**NAVFAC SPECIFICATION
08-1428**

AMENDMENT NO. 0002

14. DESCRIPTION OF AMENDMENT/MODIFICATION (Organized by UCF section headings, including solicitation/contract subject matter where feasible.) P1227, BEQ, WOUNDED WARRIOR BATTALION, MCB, CAMP LEJEUNE, NORTH CAROLINA RECEIPT OF PROPOSALS ARE HEREBY BEING POSTPONED AS FOLLOWS: FROM 3 NOVEMBER 2008 @ 2:00 PM TO: 7 NOVEMBER 2008 @ 2:00 PM ALL BID INQUIRIES MUST BE SUBMITTED NO LATER THAN 10 CALENDAR DAYS FROM THE DATE OF RECEIPT OF PROPOSALS. SEE CONTINUATION SHEET sharon.taylor@navy.mil 757-322-8258				
Except as provided herein, all terms and conditions of the document referenced in Item 9A or 10A, as heretofore changed, remains unchanged and in full force and effect.				
15A. NAME AND TITLE OF SIGNER (Type or print)		16A. NAME AND TITLE OF CONTRACTING OFFICER (Type or print)		
		TEL:	EMAIL:	
15B. CONTRACTOR/OFFEROR _____ (Signature of person authorized to sign)	15C. DATE SIGNED	16B. UNITED STATES OF AMERICA BY _____ (Signature of Contracting Officer)		16C. DATE SIGNED 23-Oct-2008

AMENDMENT 0002

C2

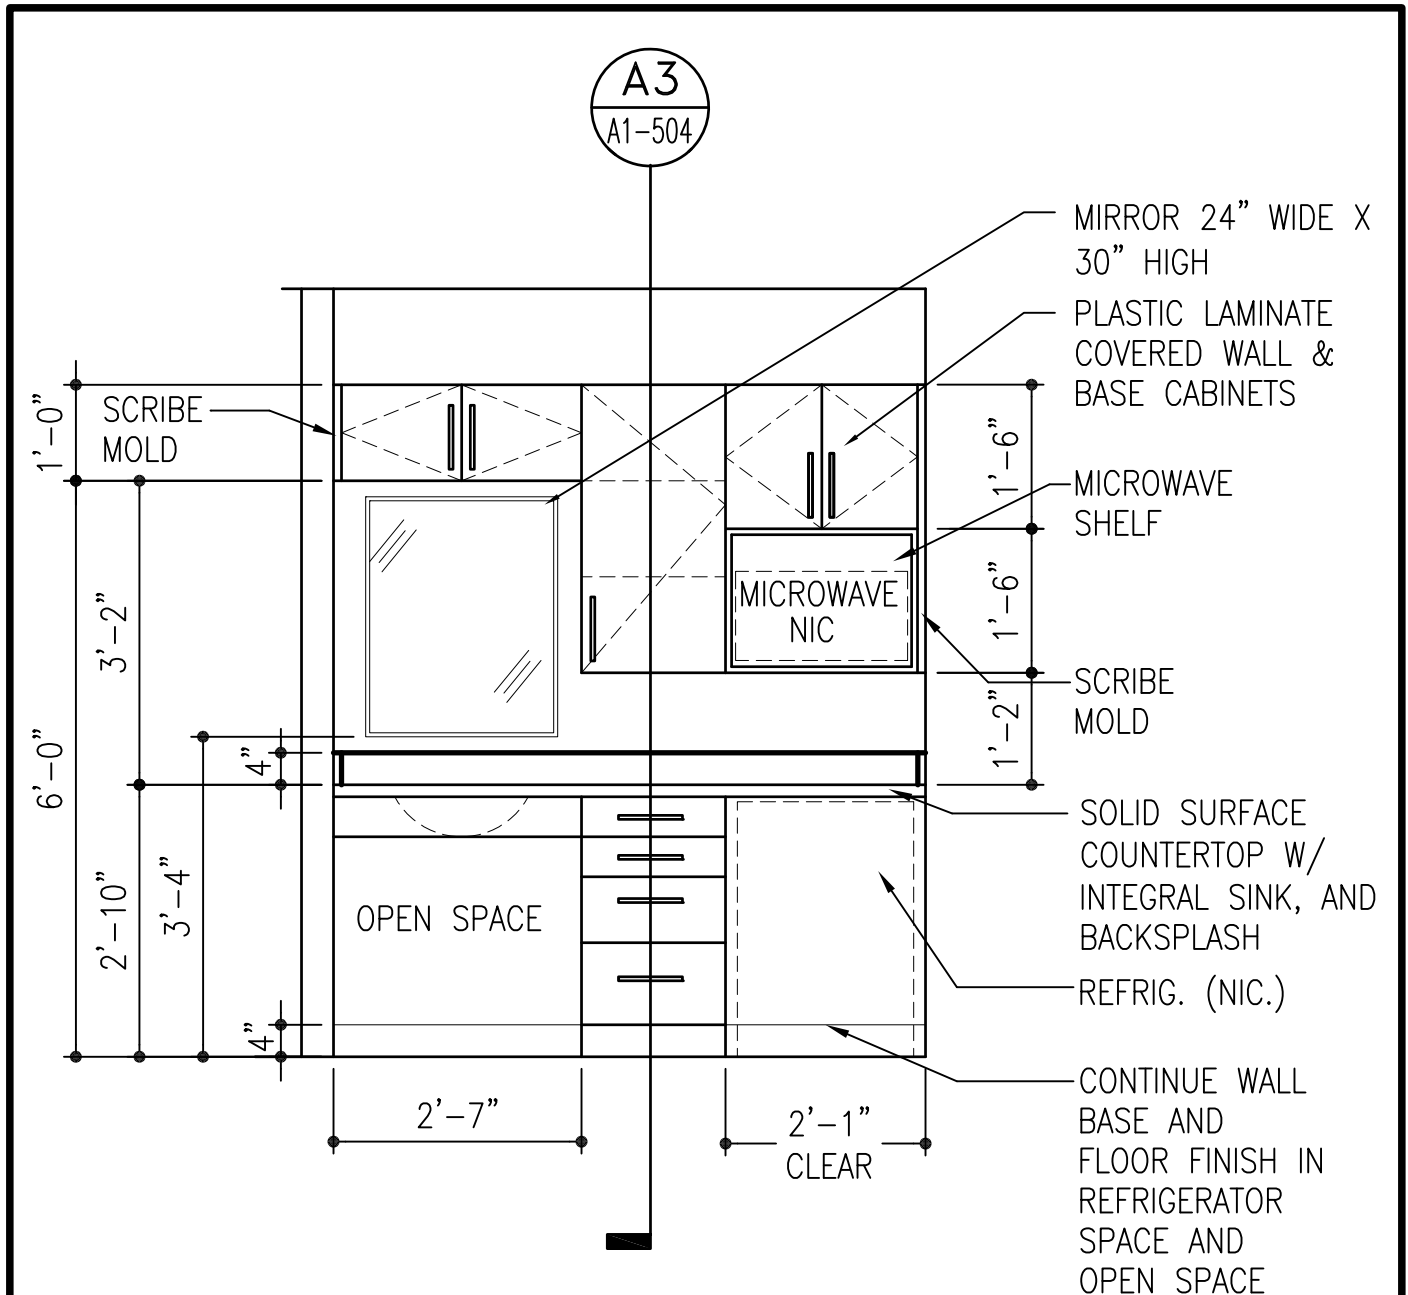
21. We note that this facility is designed with ADA guidelines in mind (such as additional grab bars in toilets and railings in the corridors; however, none of the unit kitchenette cabinets are designed for handicap access. Is this correct?

NOTE:
ALL FIRST FLOOR UNITS

RESPONSE: See sketches SKA-003 and SKA-004, which have been added by amendment.

C3

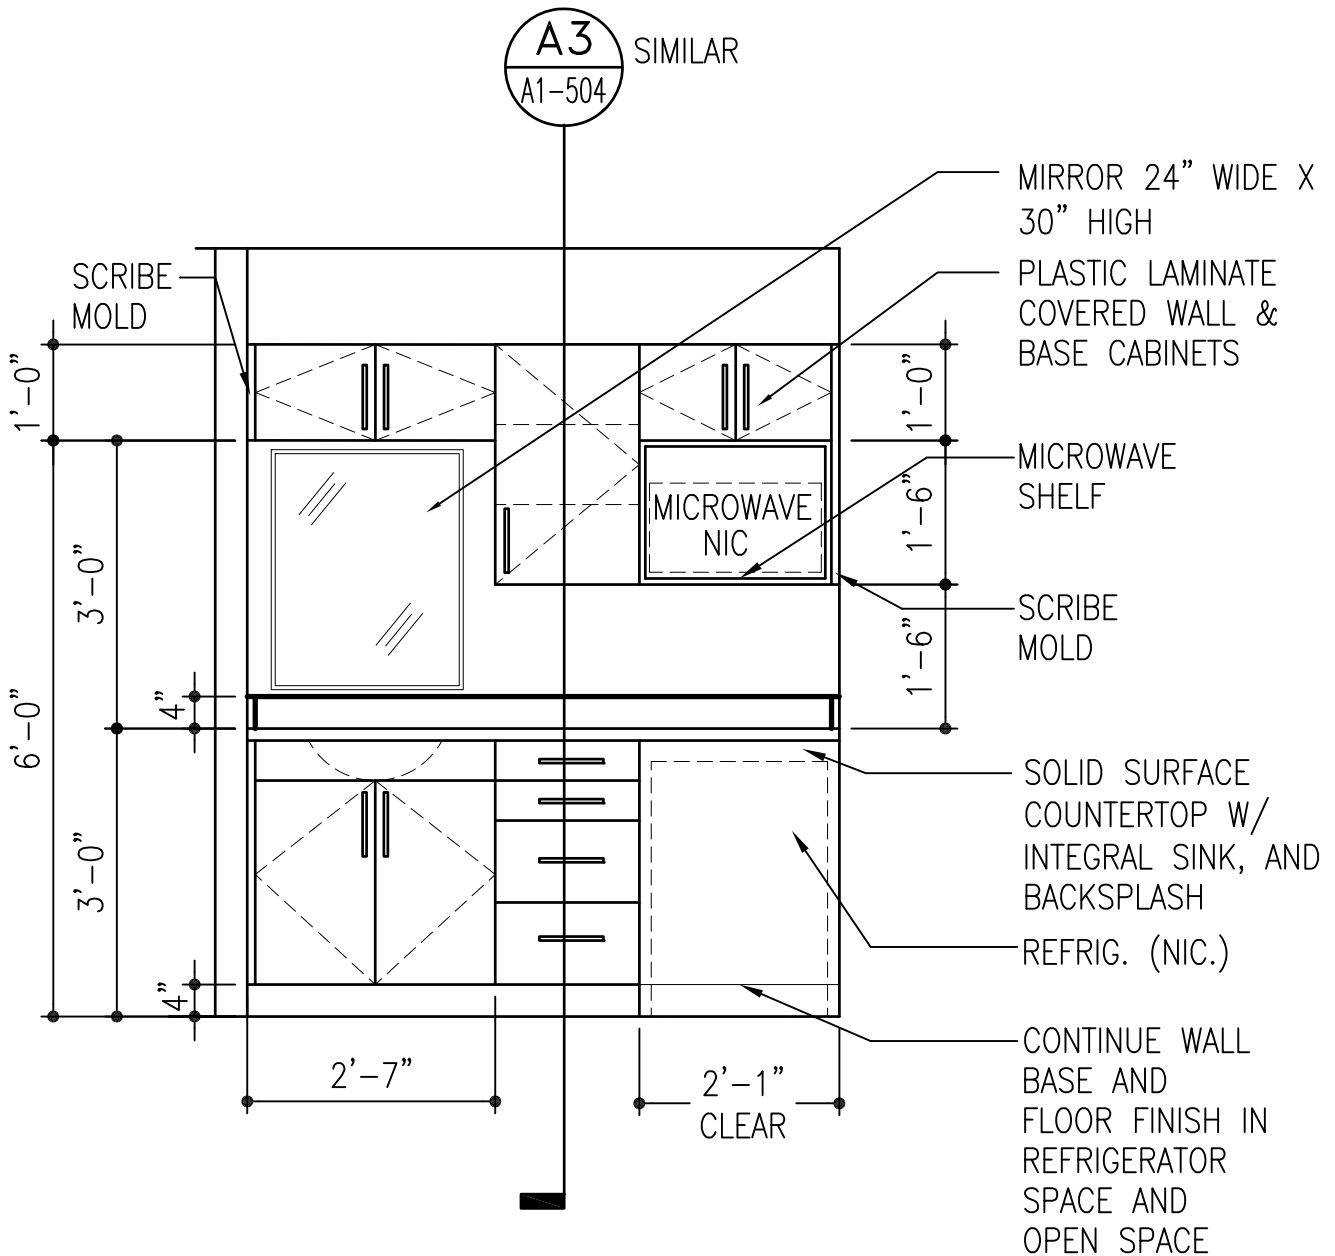
NOTE:

ALL SECOND AND THIRD FLOOR UNITS
